FINAL DESIGN PACKAGE
AIR SPARGE/SOIL VAPOR
EXTRACTION SYSTEM

FOR RITE-OFF, INC.
BAY SHORE, NEW YORK
SUFFOLK COUNTY

NYSDEC SITE #1-52-129

JANUARY 1997

FIGURE 1
RITE-OFF
AS/SVE SYSTEM
CONCEPTUAL DESIGN

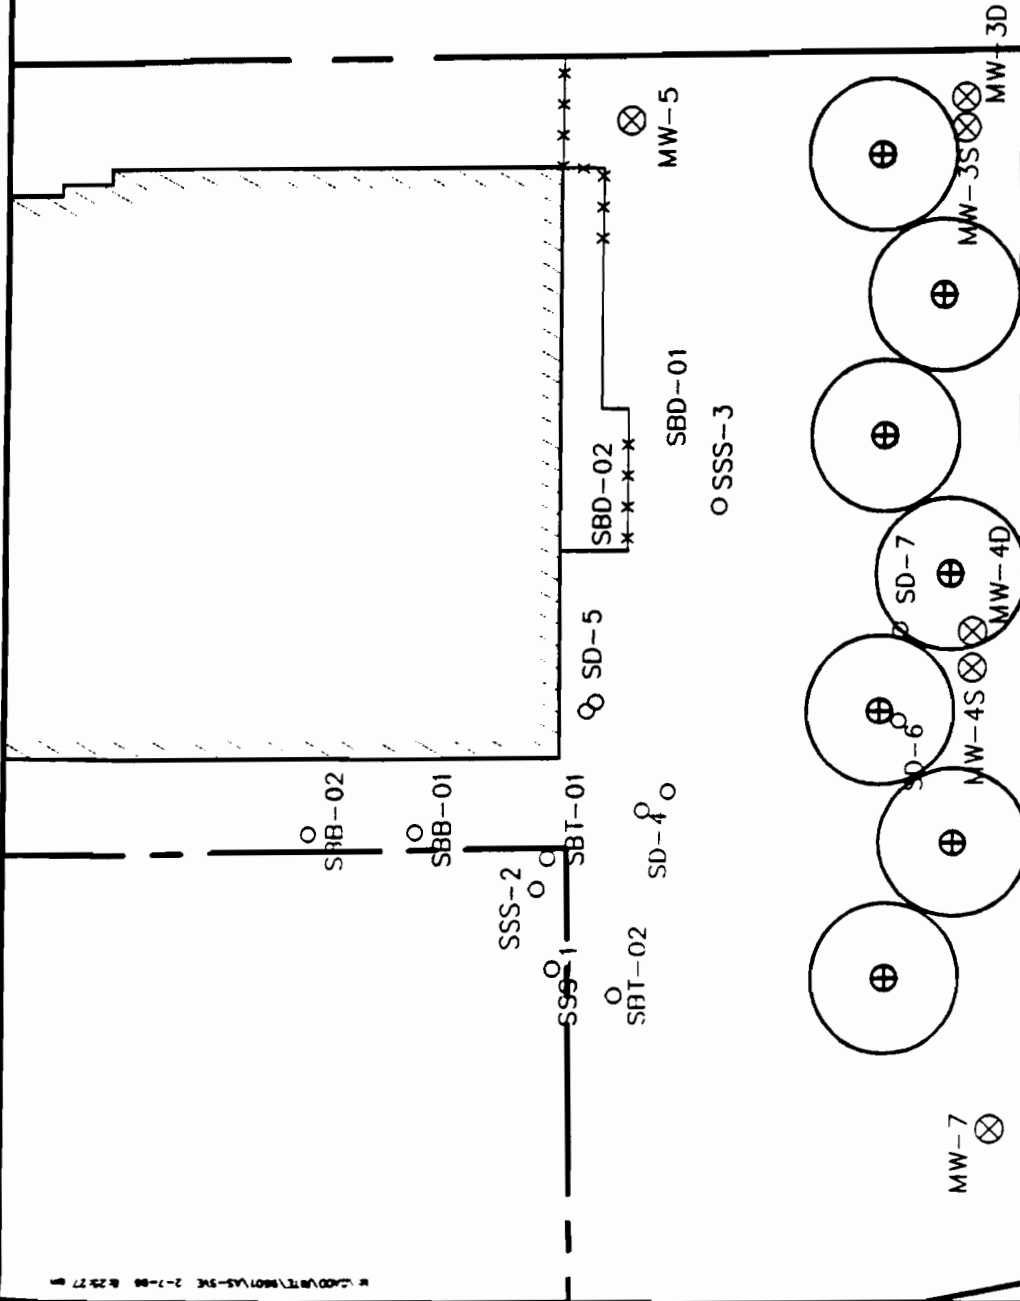
As envisioned, the AS system would consist of seven air-sparge points installed in a staggered line parallel to the southern property line of the site (see Figure 1). Each sparge point will be set at a depth of approximately 40 feet below ground surface (bgs) and air will be injected through each point to volatilize the COCs. The optimum air-injection rates will be determined through system pilot tests and start up tests. We have assumed a conservative 20-foot radius of influence for the AS system for this conceptual design.

FIGURE 1
RITE-OFF

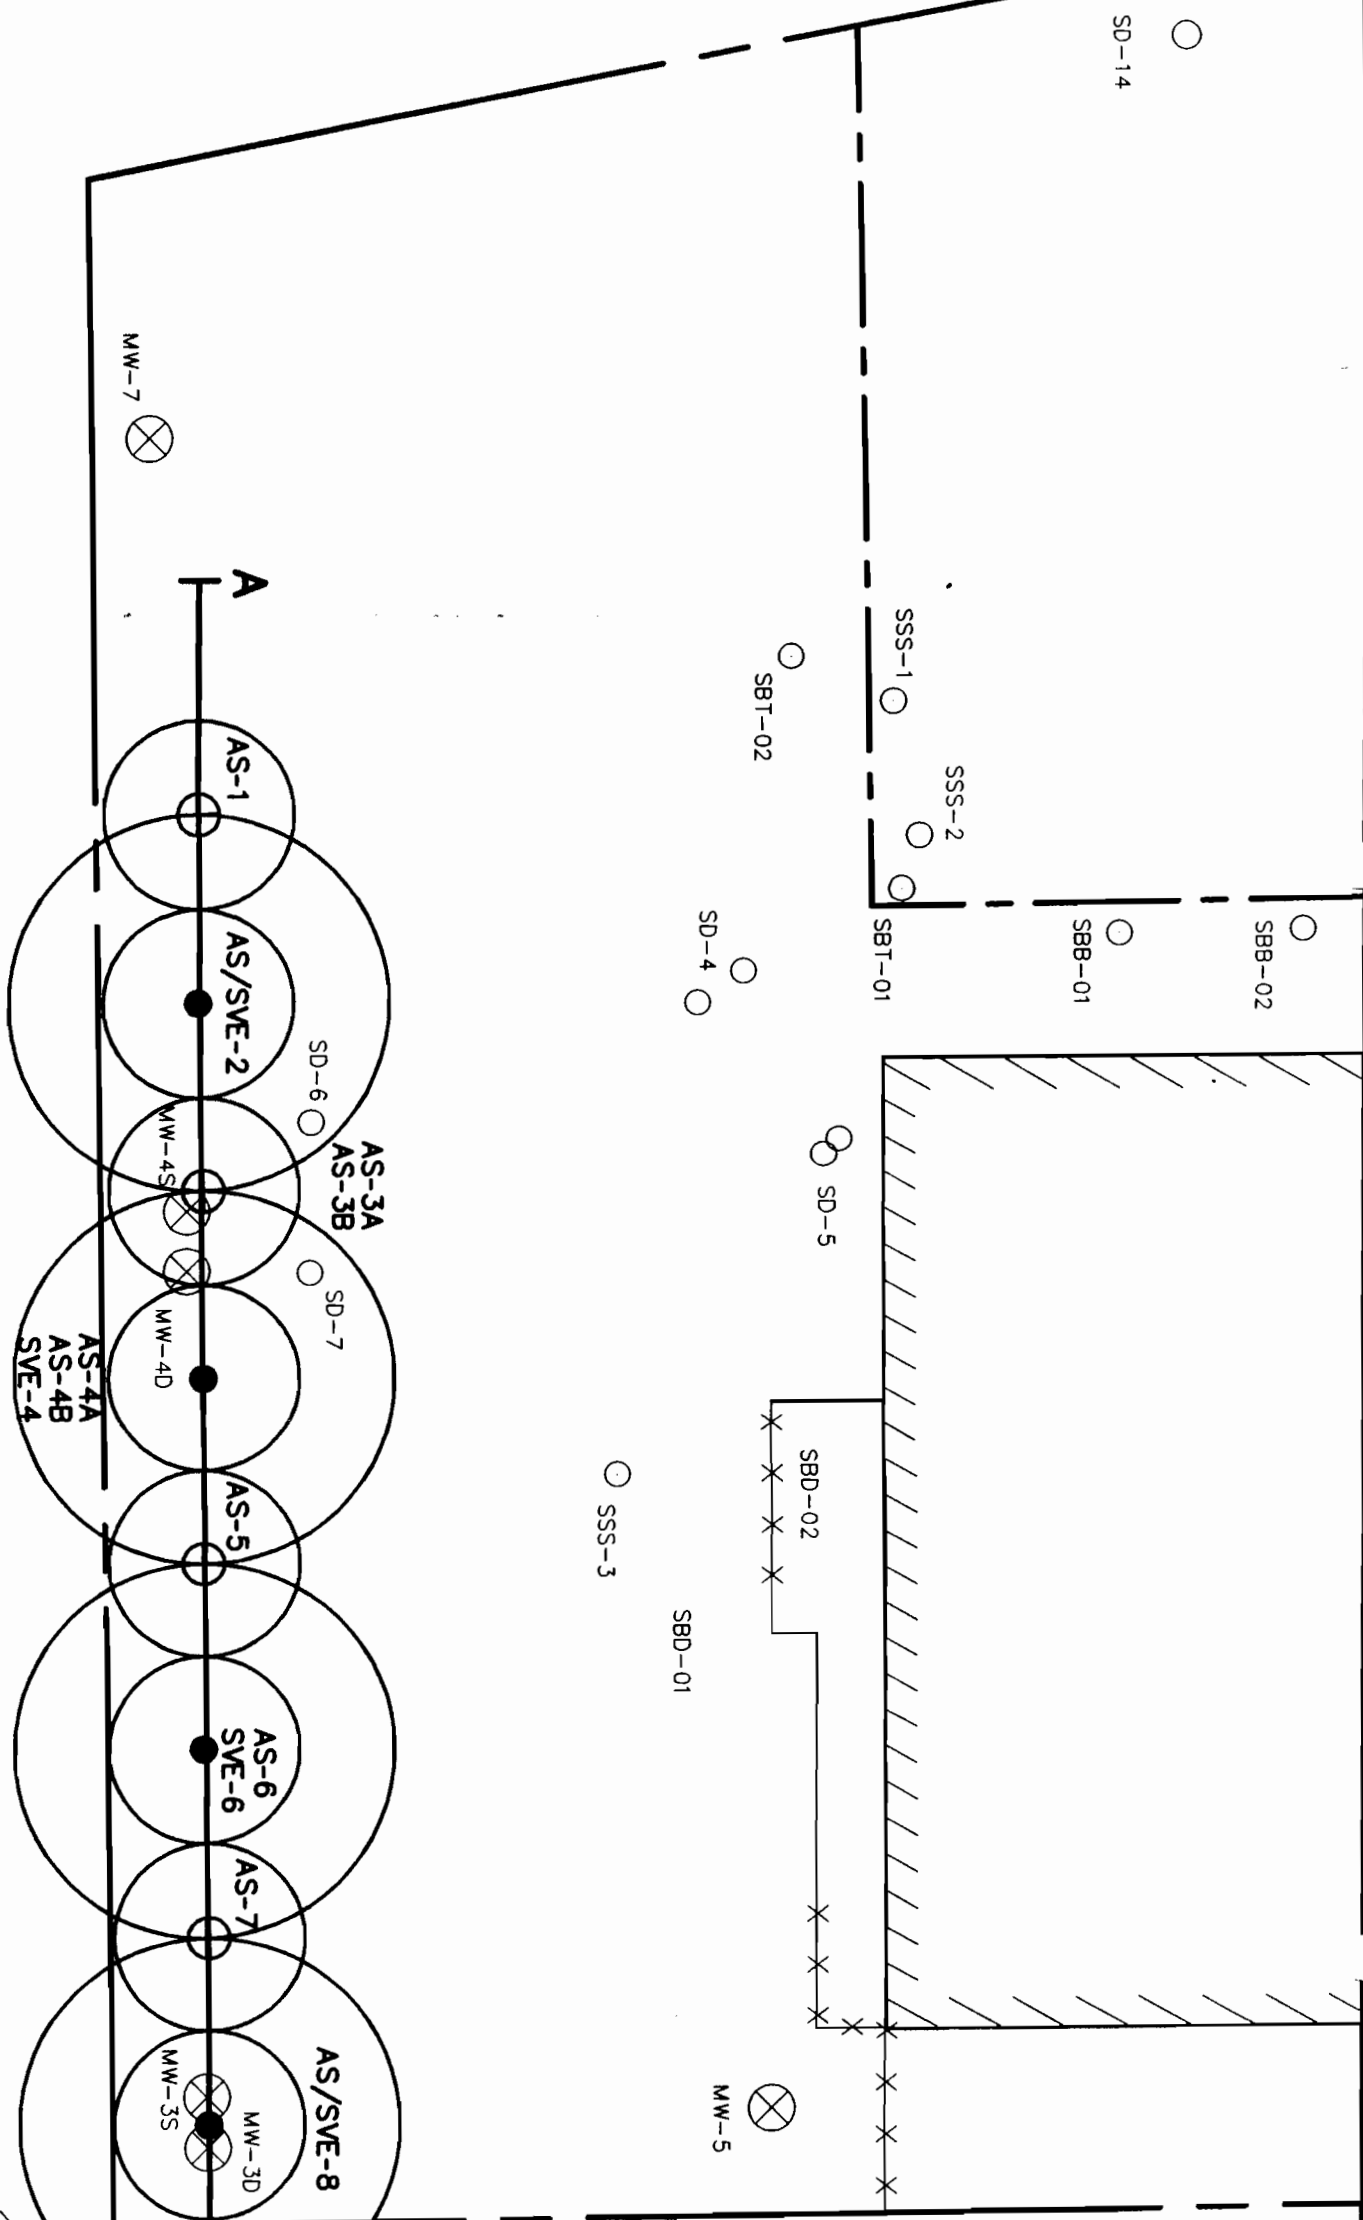
As shown in Figure 1, we have assumed a conservative radius of influence for the AS wells of 15 feet. A total of ten AS wells are planned to provide the required coverage. As shown on Figure 2, eight 32-foot deep AS wells will be installed along the southern property line of the site. These AS wells will have two-foot long screened intervals placed 10 feet beneath groundwater. At the two AS points located near Leaching Pools SD-6 and SD-7, we are proposing that two additional AS points, equipped with 2-foot long screens, be installed to approximately 42-feet below ground surface (bgs)

FIGURE 3
RITE-OFF
DETAILS OF CLUSTERED WELLS
AS/SVE SYSTEM DESIGN

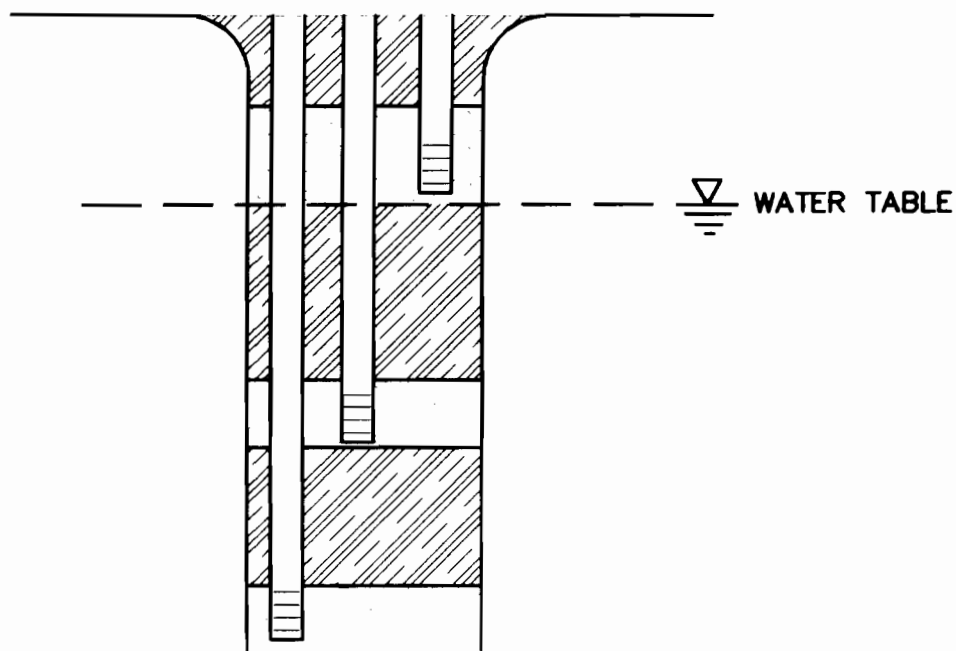
In the locations with two or more AS and/or SVE wells, the wells will be installed within the same boring (see Figure 3). To prevent air leakage, only the annular space around the screened zones of each well within a cluster will be filled with filter pack sand. The remaining annular spaces will be filled with a non-permeable material such as hydrated bentonite pellets.

FIGURE 2
RITE-OFF
AS/SVE SYSTEM INITIAL DESIGN
SITE/SYSTEM CROSS SECTION

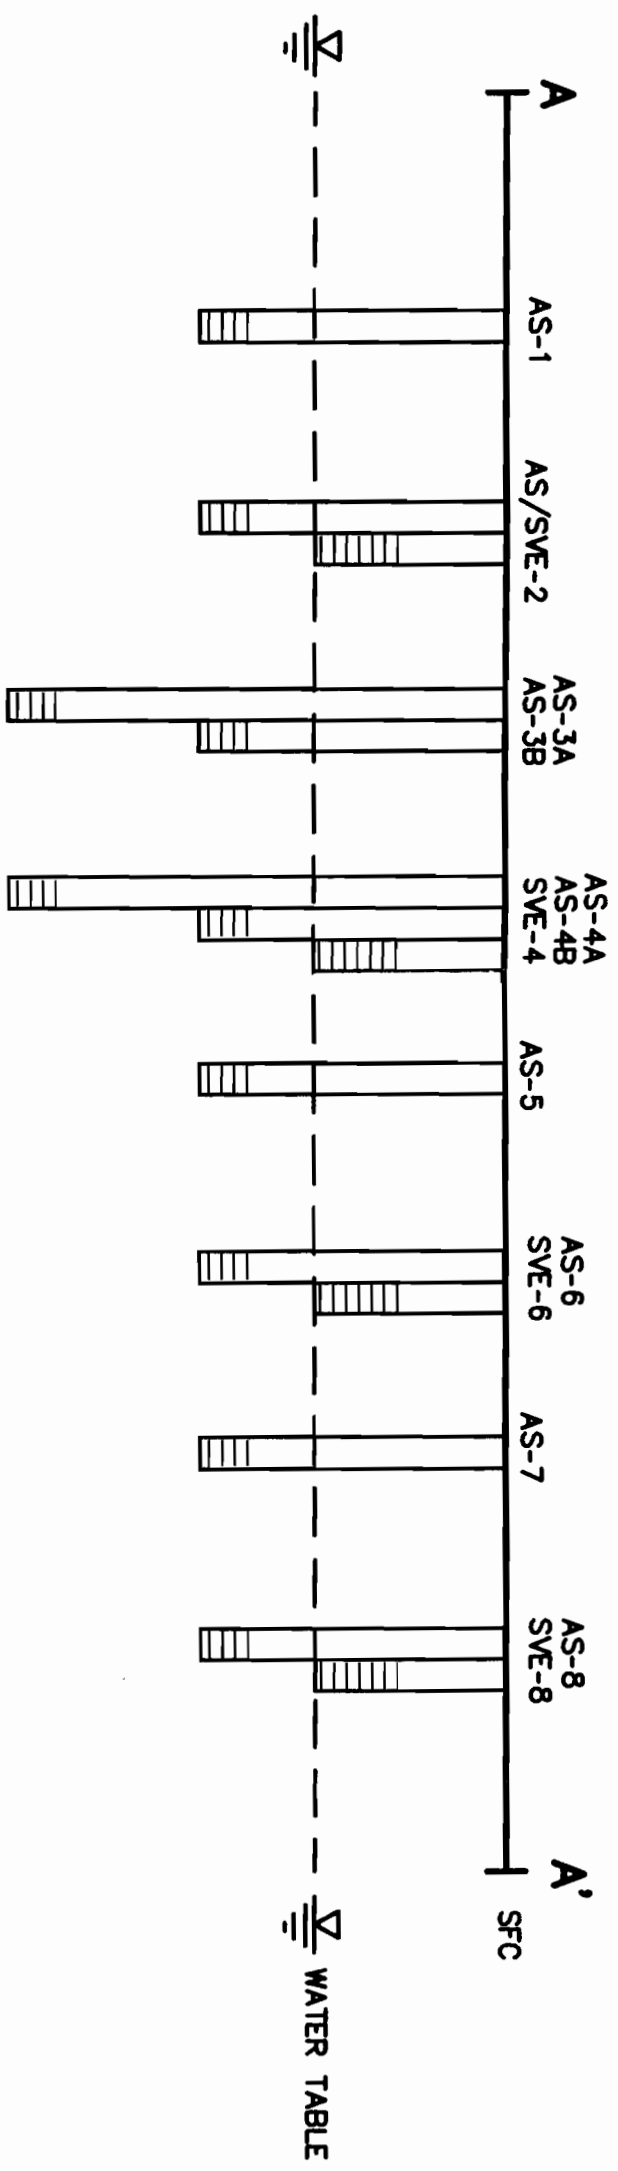
As shown in Figure 1, we have assumed an conservative radius of influence for the AS wells of 15 feet. A total of ten AS wells are planned to provide the required coverage. As shown on Figure 2, eight 32-foot deep AS wells will be installed along the southern property line of the site. These AS wells will have two-foot long screened intervals placed 10 feet beneath groundwater. At the two AS points located near Leaching Pools SD-6 and SD-7, we are proposing that two additional AS points, equipped with 2-foot long screens, be installed to approximately 42-feet below ground surface (bgs).

FIGURE 3
RITE-OFF
DETAILS OF CLUSTERED WELLS
AS/SVE SYSTEM DESIGN

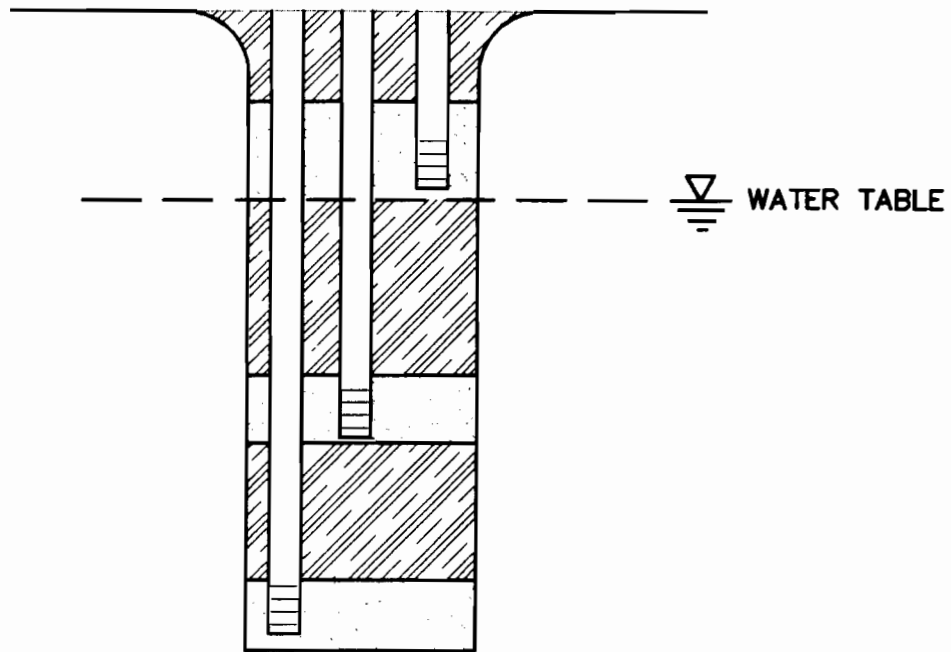
In the locations with two or more AS and/or SVE wells, the wells will be installed within the same boring (see Figure 3). To prevent air leakage, only the annular space around the screened zones of each well within a cluster will be filled with
